PC190062: Private Plan Change Leeston – Request for further information

Your application for the above plan change has been assessed for completeness under the First Schedule of the Resource Management Act 1991. A review has been undertaken of the application, with the following further information request being issued, to enable Council to better evaluate the nature and effects of the request (Clause 23(1)):

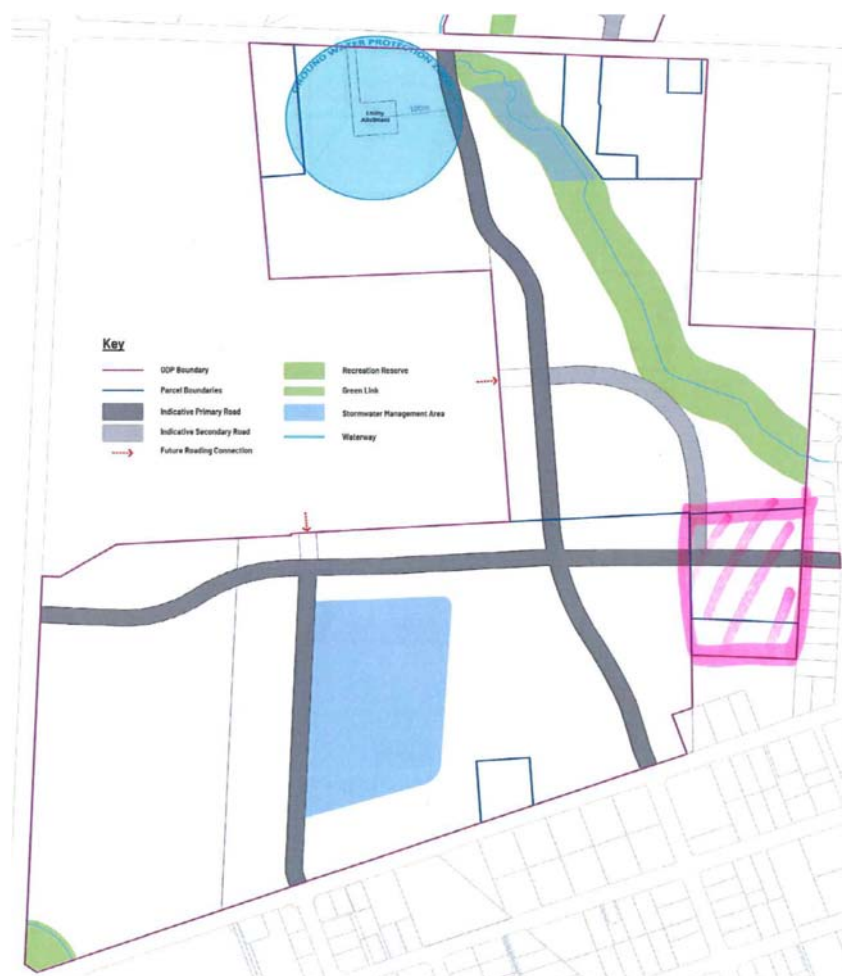
Please also advise how stormwater in the area shaded in pink below is to be managed in terms of water quality and quantity.

As highlighted in yellow below, the ODP should show a specific pedestrian/cycle link along the main reserve/water course alignment. The ODP should also show a pedestrian/cycle link from the northern part of the to the future stormwater reserve area along the northern boundary of the site.
